10 **SEDGWICK CO COURTHOUSE – DA 2ND & 3RD FLOOR
REMODEL
Sedgwick County**

20 Prepared by:
Schaefer Johnson Cox Frey Architecture, Inc.

PRE-BID QUESTIONS:

E22.1

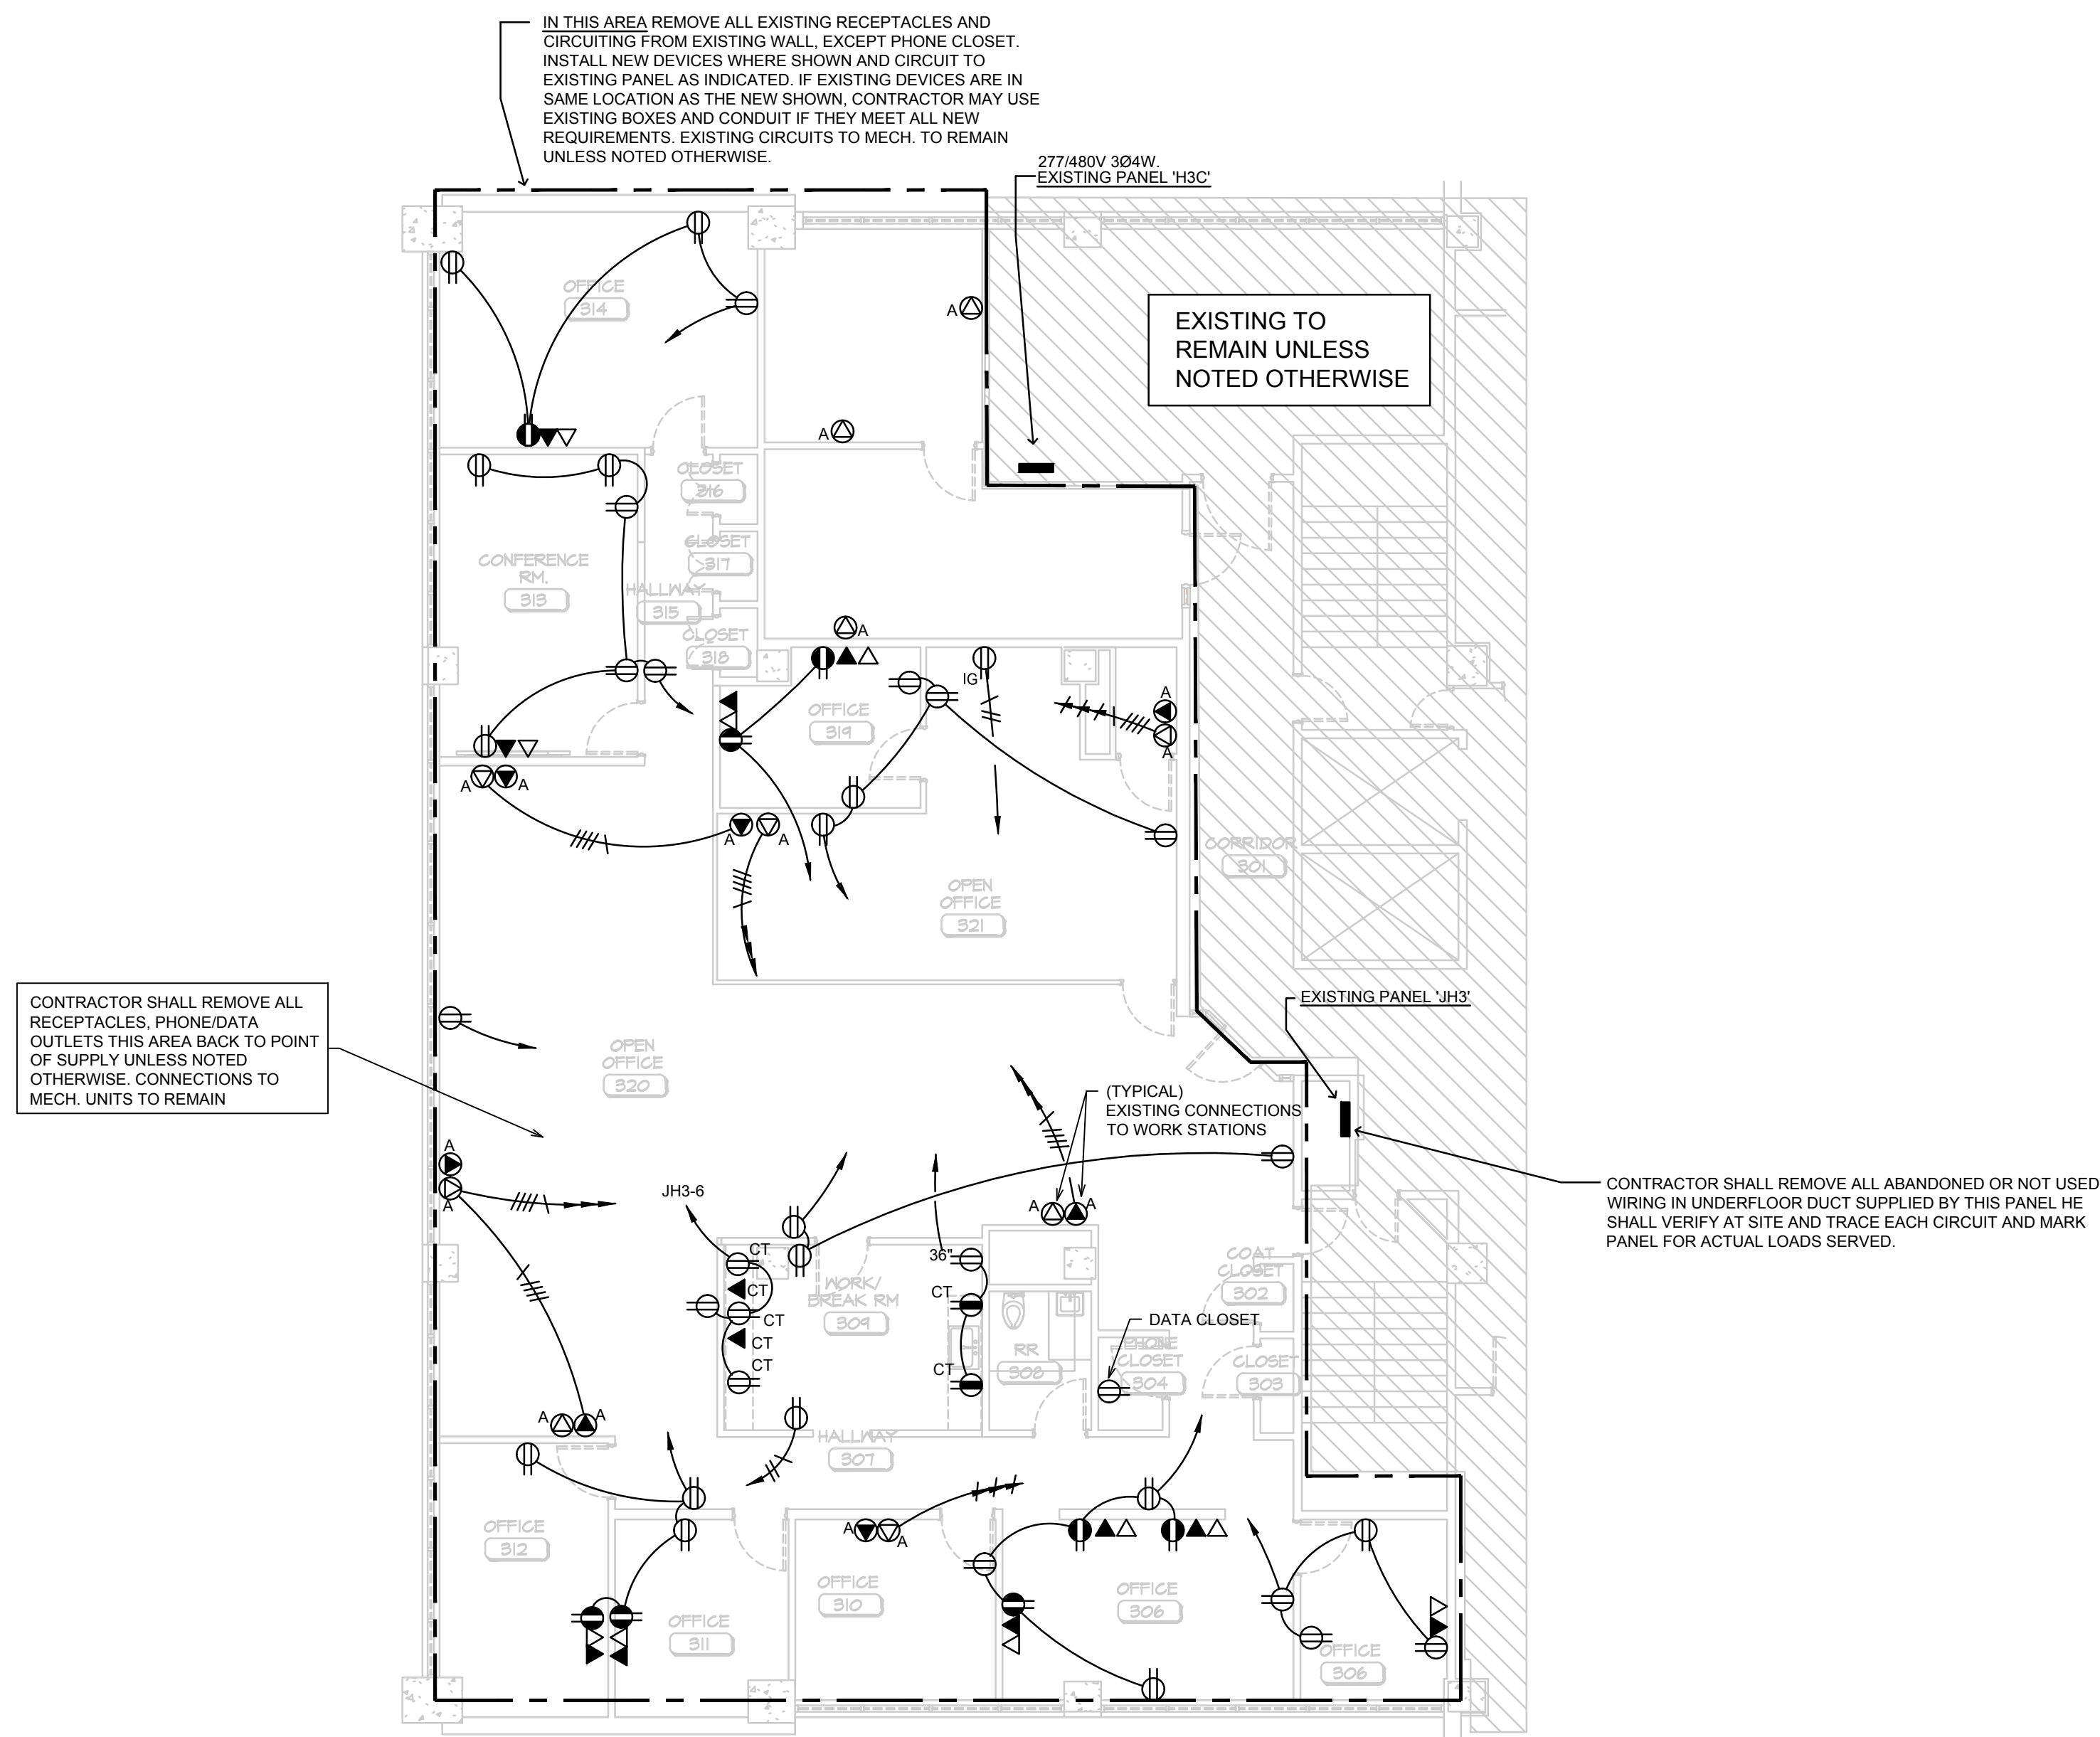
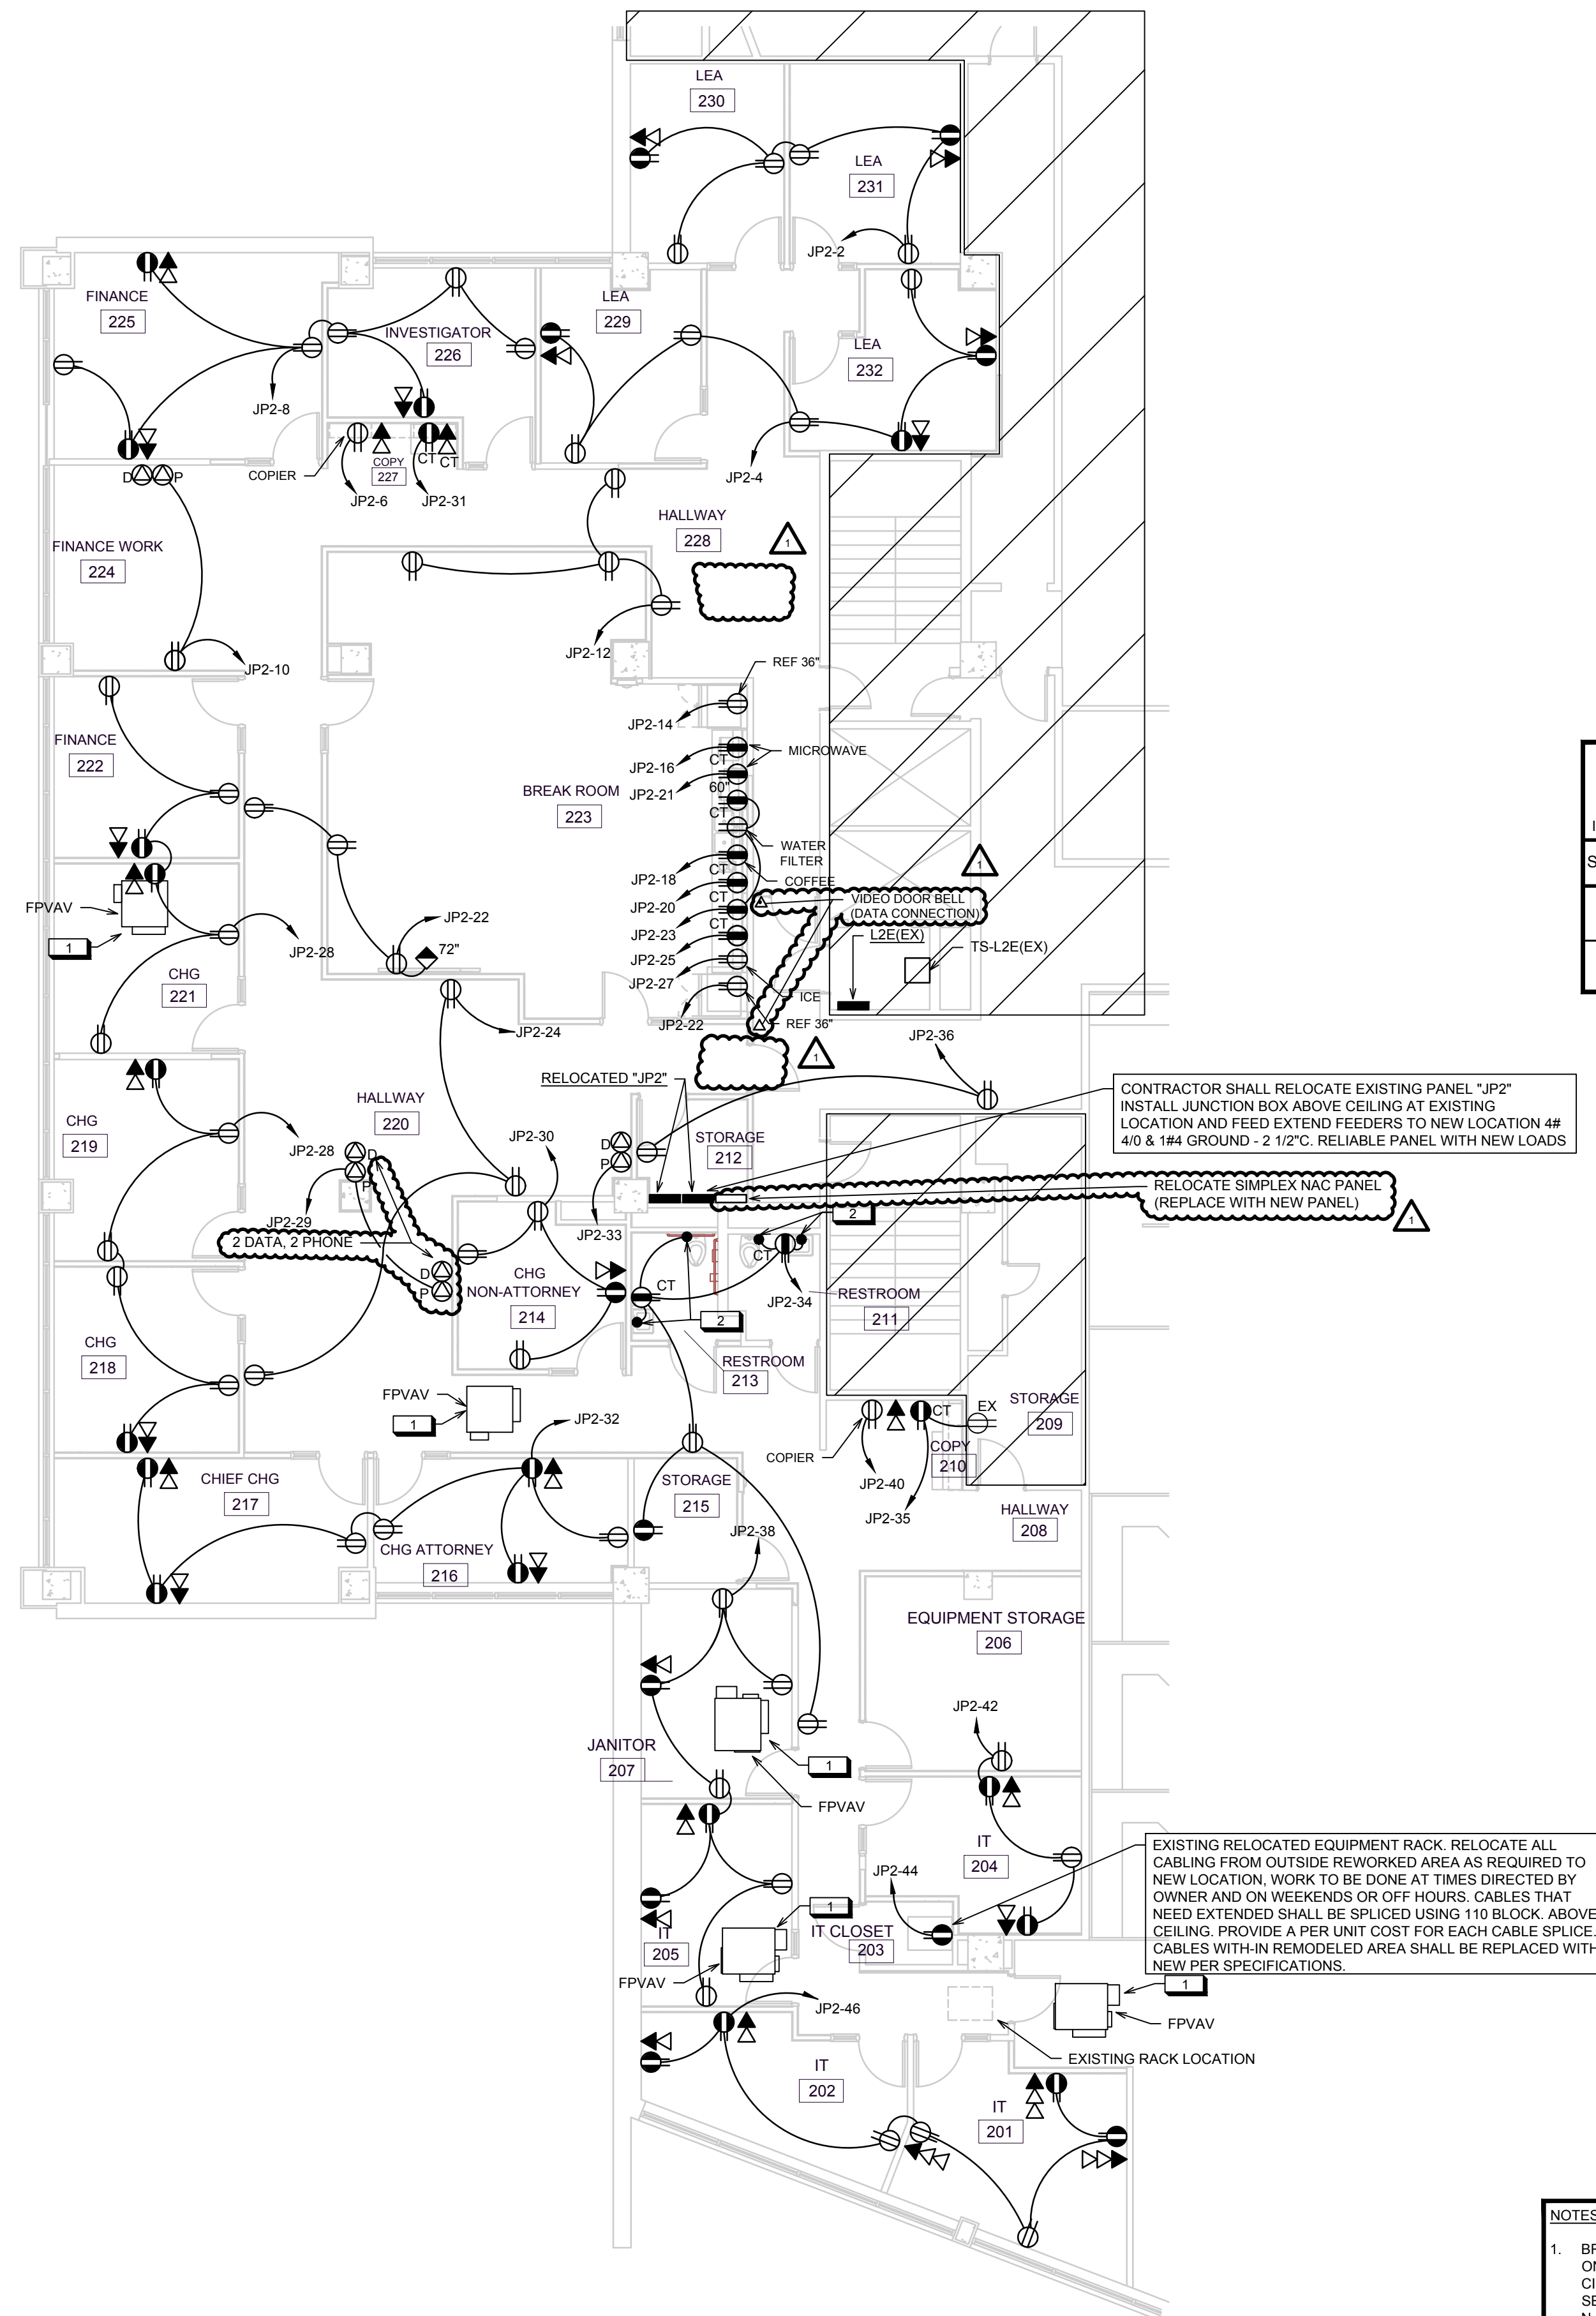
DRAWING SHEET E22.1:
Added a new NAC panel per attached revised sheet.
